Agenda
Technical Committee on
Single- and Multiple-Station Alarms and Household Signaling Systems (SIG-HOU)
First Draft Meeting
Indianapolis, IN
July 22 - 24, 2019

TECHNICAL COMMITTEE ON SINGLE- AND MULTIPLE-STATION ALARMS AND HOUSEHOLD FIRE ALARM SYSTEMS NFPA Second Draft Meeting (A2018)

Figure A.29.5.3 Four Pulse Temporal Pattern.

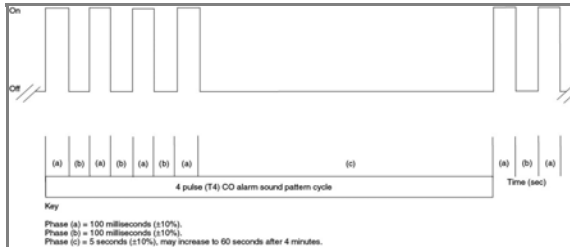
**Public Input No. 275-NFPA 72-2019 [Section No. A.29.5.3]****A.29.5.3**

The four pulse temporal pattern is illustrated in Figure A.29.5.3.

Replace the text of the figure to read as follows: Phase (c) = 5 seconds (+-10%), should be permitted to increase to 60 seconds after 4 minutes.

Figure A.29.5.3 Four 4 Four Pulse Temporal Pattern.

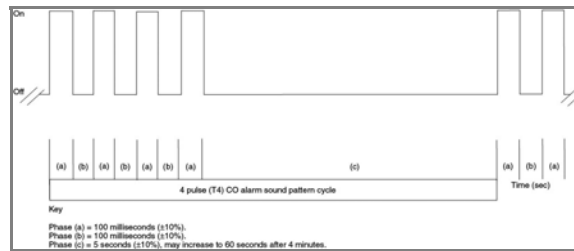
The four pulse temporal pattern is illustrated in Figure A.29.5.3 4 .

Figure A.29.11.3.4(4)(a) Example of Zone of Exclusion (gray area) Within Typical Residential Kitchen.

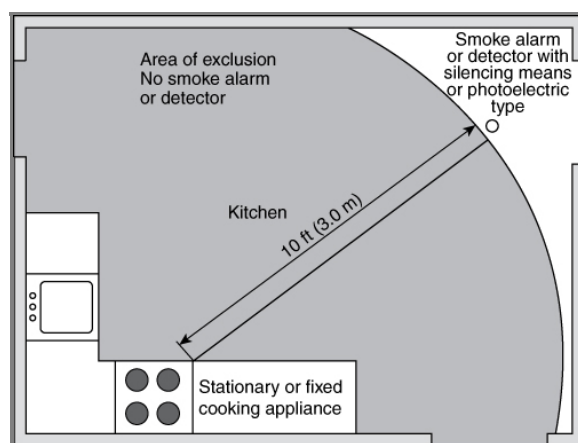
~~Smoke alarms and smoke detectors that are currently available to consumers are susceptible to particles released into the air during normal cooking procedures. If smoke alarms and smoke detectors are placed too close to the area where the cooking source originates, a high level of nuisance alarms can occur. Frequent nuisance alarms can result in an occupant disabling the smoke alarm or smoke detector.~~

Nuisance alarm studies provide data on cooking nuisances that emanate from both fixed cooking appliances and stationary cooking appliances (e.g., stove, oven) as well as portable cooking appliances (e.g., toaster). Based on these studies, which demonstrate the potential of all cooking appliances to generate nuisance sources, a zone of exclusion has been specified surrounding each stationary or fixed cooking appliance. The purpose of this zone is to limit the installation of smoke alarms and detectors in areas where stationary, fixed, or portable cooking appliances will be located within the residential kitchen space such that potential nuisance alarms are minimized. The size of the zone of exclusion is specified to attempt to take into account the unknown and transitory locations of portable cooking appliances. This zone of exclusion is determined by measuring a 10 ft (3.0 m) radial distance from the closest edge of a stationary or fixed cooking appliance. The zone of exclusion is not intended to pass through walls or doorways. Figure A.29.11.3.4(4)(a) provides an example of the zone of exclusion in a generalized residential kitchen.

Figure A.29.11.3.4(4)(b) Example of Smoke Alarm or Smoke Detector Placement Between 10 ft (3.0 m) and 20 ft (6.1 m) Away in Hallway from Center of Stationary or Fixed Cooking Appliance.

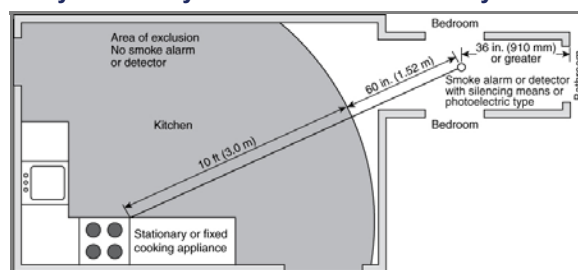
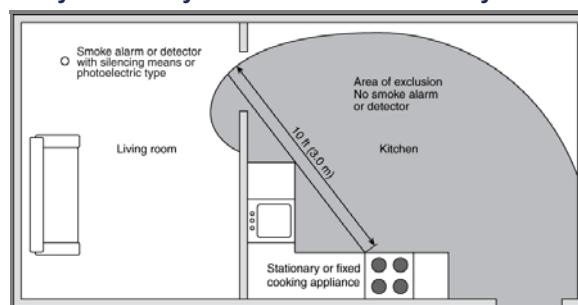
To install a smoke alarm or detector between 10 ft (3.0 m) and 20 ft (6.1 m) from the cooking appliance, an installer must first determine the 10 ft (3.0 m) area of exclusion. Once the area of exclusion is determined, an installer must then determine the horizontal flow distance. This is the horizontal distance along the ceiling from the closest edge of the cooking appliance to the smoke alarm or detector. The horizontal distance can consist of line segments due to impediments, such as interior partitions. Once an impediment is met, the measurement of the distance will then continue along the new horizontal path segment until the distance requirement is met or another impediment is encountered. Figure A.29.11.3.4(4)(b) provides an example for placement outside a kitchen in a nearby hallway. Figure A.29.11.3.4(4)(c) provides another example of appropriate placement outside of a kitchen in an adjacent room.

Figure A.29.11.3.4(4)(c) Example of Smoke Alarm or Smoke Detector Placement Between 10 ft (3.0 m) and 20 ft (6.1 m) Away in Hallway from Center of Stationary or Fixed Cooking Appliance.

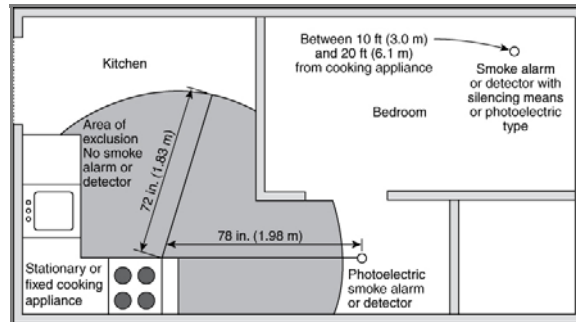
At a horizontal flow path distance of greater than 20 ft (6.1 m), any type of smoke alarm or smoke detector can be installed.

In rare cases, a residential dwelling can be of such size and configuration that an area of exclusion of 10 ft (3.0 m) from a stationary or fixed cooking appliance excludes the placement of a smoke alarm or smoke detector required by other areas of this Code. In these cases, a smoke alarm or smoke detector using photoelectric detection can be installed at least 72 in. (1.83 m) from the fixed or stationary cooking appliance. Figure A.29.11.3.4(4)(d) provides an example of this situation in practice where a smoke alarm or smoke detector is required outside of the sleeping area, but the space is in close proximity to the kitchen space.
